STATE OF ILLINOIS  
DEPARTMENT OF TRANSPORTATION

ROUTE NO.	SECTION	COUNTY	TOTAL SHEETS	SHEET NO.	SHEET NO.
1774	113(B-5,6,7)	LOGAN	60	44A.	SHEETS
FED. ROAD DIST. NO. 7		ILLINOIS	FED. AID PROJECT-

Contract # 72760

**CONCRETE PARAPET  
SLIPFORMING OPTION**

**SECTION**  
(Showing dimensions)

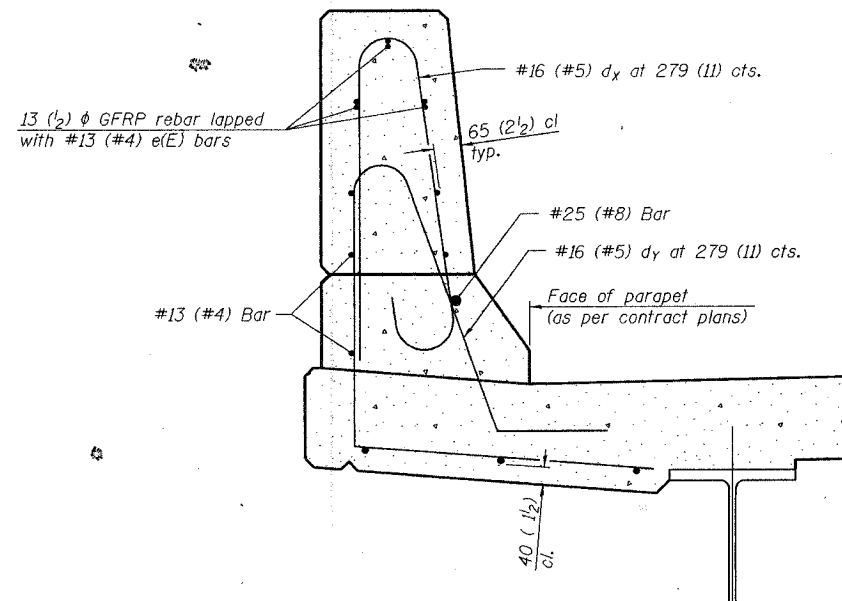
All dimensions shall remain the same as shown on contract plans, except dimensions A and B which are to be revised as shown to provide additional clearance. Additional concrete needed to revise dimension A and B= 0.0422 m<sup>3</sup>/m (0.165 cu. yds./ft.) of parapet. Place aluminum sheet in curb portion at and near piers. Full thickness saw cut at all other locations. Adjust/add joint locations to maintain 3 to 6 meter (10 to 20 foot) spacing.
